ALTA GROVE AT MOUNTAIN ISLAND

ATTACHED TO ADMINISTRATIVE APPROVAL
 DATED: 04/09/2001
 BY: MARTIN R. CRAMTON, JR.
 98-696 + 98-126

SITE PLAN

DATE: April 9, 2001
 TO: Robert Brandon, Zoning Administrator
 FROM: Martin R. Cramton, Jr., Planning Director
 SUBJECT: Administrative Approval for Petition No. 98-126 and 98-696 by Kelly Dunbar.

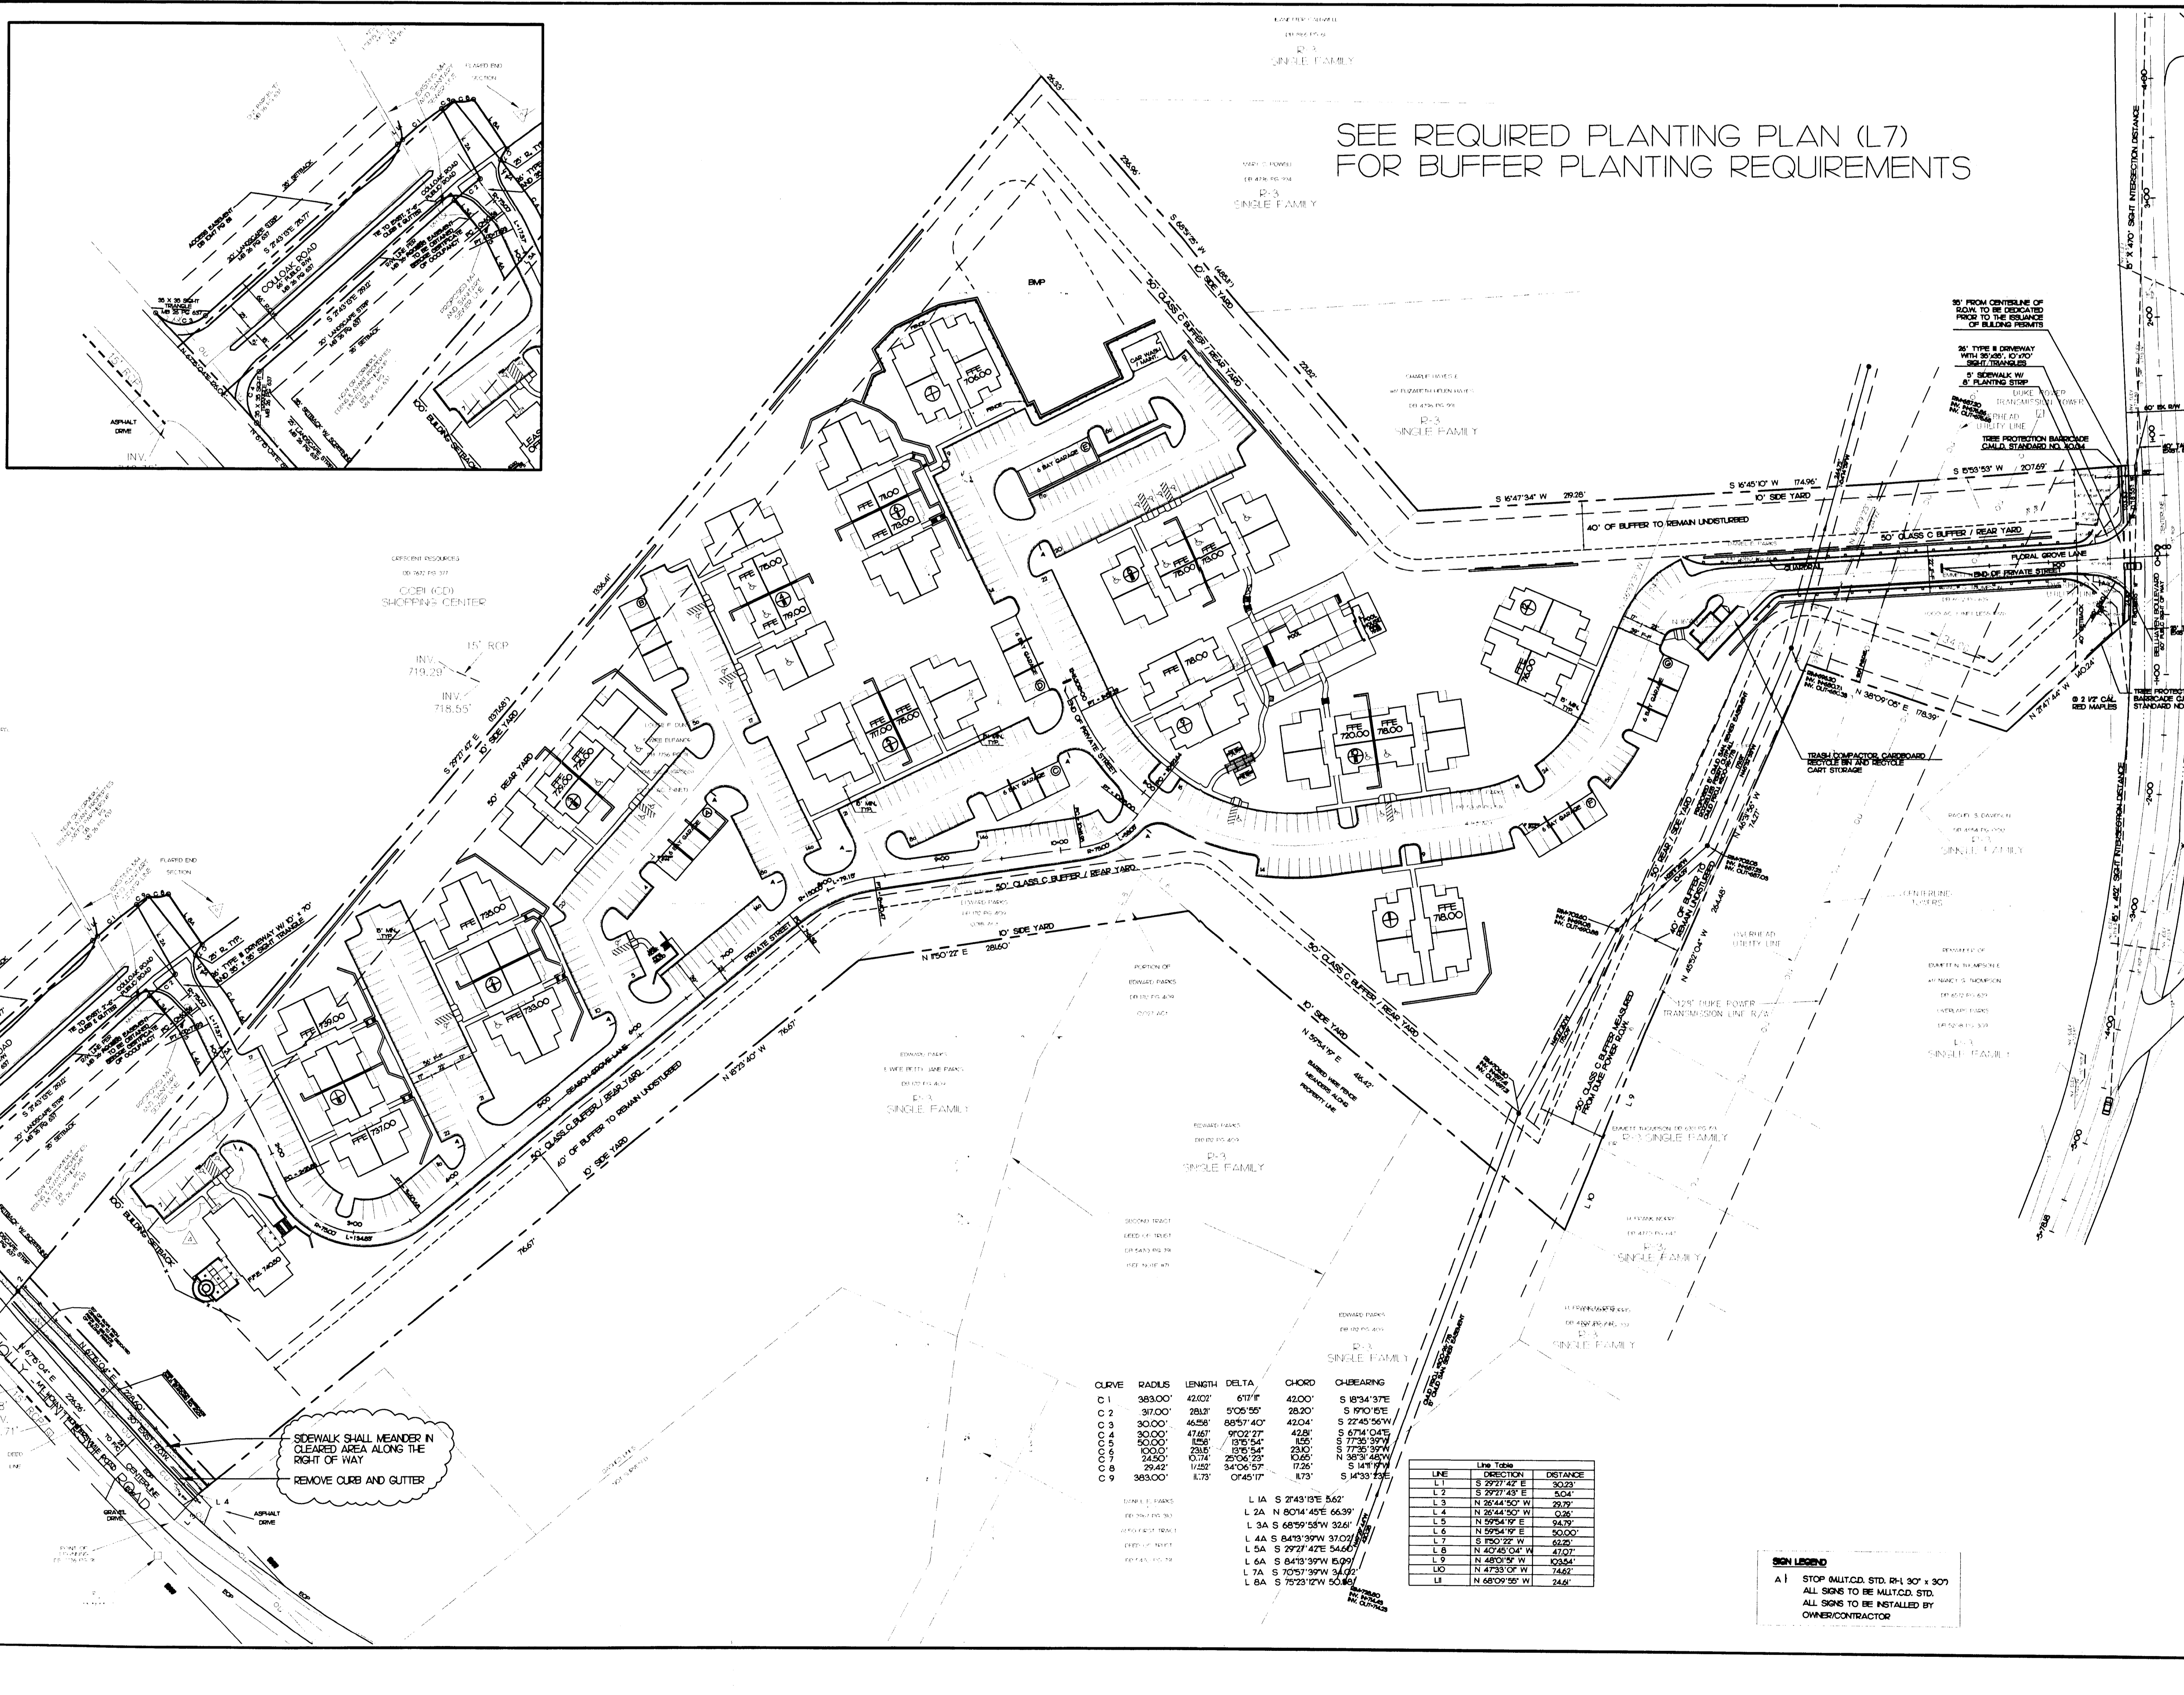
Scale: 1" = 60'
 Date: MARCH 24, 1999
 Revisions:
 1 JUNE 1999 PER C.M.P.C. REVIEW
 23 JUNE 1999 PER C.M.P.C. & ENG. REVIEW
 24 AUG 99 C.M.P.C. & ENG REVIEW
 4 B JUNE 00 PER GRAYCO
 9 APRIL 5, 2001 REMOVE CURB AND GUTTER
 Sheet L3 of

Attached is the revised plan for the above petitions, which eliminates the requirement for curb and gutter along Mt. Holly-Hunterville Road. The Engineering Department recommends deleting this requirement due to site conditions. Since this change is minor, I am administratively approving this plan. Please use this plan when evaluating requests for building permits and certificates of occupancy.
